# Access Compliance Report

## Public Rights-of-Way

Intersection ID: 28305	Main Street: COMMUNITY_HOUSE_RD	Cross Street: TAMARRON_DR	Location: E
ADA ID: 2394F20EF2CB	Ramp Type: BlendTrans2	Initial Pass/Fail: Fail	Overall Compliance: No
Severity Score: 12.5			
Codes/Mitigation Info/Possible Solution		Field Measurements/Component Compliance

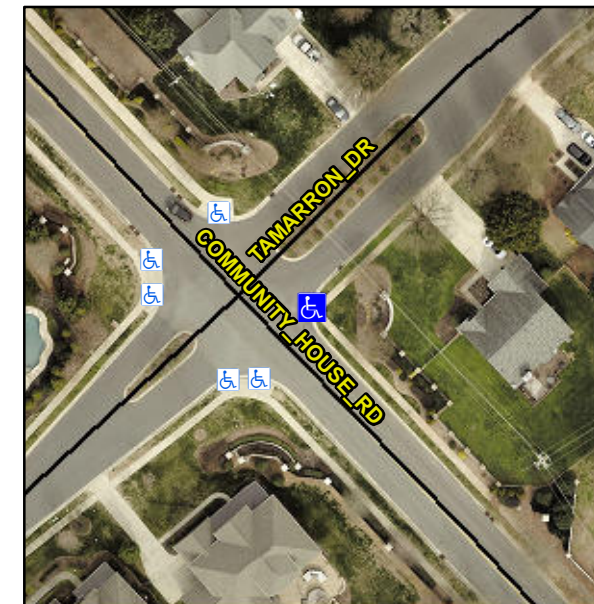
**Remove & Replace Curb Ramp With Two New Directional Ramps or Equivalent.**

**Not Found, R304.5.3**

Compliance	Description	Data	Compliance	Description	Data
N/A	Ramp Length (in)	39.0	Yes	BlendTrans Slope (%)	3.3
Yes	Ramp Width (in)	48.0	No	BlendTrans XSlope (%)	5.9
N/A	Flare Type LT	N/A	N/A	Flare Type RT	N/A
N/A	Flare Slope LT (%)	N/A	N/A	Flare Slope RT (%)	N/A
N/A	Flare Traversable LT?	N/A	N/A	Flare Traversable RT?	N/A
N/A	Landing Length (in)	N/A	N/A	DWS Provided?	N/A
N/A	Landing Width (in)	N/A	N/A	DWS Contrast?	N/A
N/A	Landing Slope (%)	N/A	N/A	DWS Length (in)	N/A
N/A	Landing X Slope (%)	N/A	N/A	DWS Full Width?	N/A
N/A	Landing Curb? (Y/N)	N/A	N/A	DWS Offset (in)	N/A
N/A	Shared Landing?	N/A			
N/A	Gutter Ponding?	N/A	N/A	Gutter Slope (%)	N/A
N/A	Gutter Lip Ht (in)	N/A	N/A	Gutter X Slope (%)	N/A
N/A	Painted X Walk1?	No	N/A	Painted X Walk2?	No
	X Walk 1 Direction	To NW		X Walk 2 Direction	To SW
	X Walk 1 Width (in)	N/A		X Walk 2 Width (in)	N/A
	X Walk 1 Slope (%)	2.6		X Walk 2 Slope (%)	1.8
	X Walk 1 X Slope (%)	1.2		X Walk 2 X Slope (%)	2.8

N/A	Ramp inside XWalk1?	N/A	N/A	Ramp inside XWalk2?	N/A
	Road Slope (%)	2.4		Clear Space?	N/A
	Road X Slope (%)	0.4	N/A	Clear Space to XWalk (in)	N/A
N/A	Any Obstructions?	N/A	N/A	Storm Grate/Utility Hazard?	N/A
	Obstruction Type			Storm Grate/Utility Type	
		N/A			N/A
			Yes	Surface Condition? (G/P)	Good
			No	Curb Slope (%)	18.2
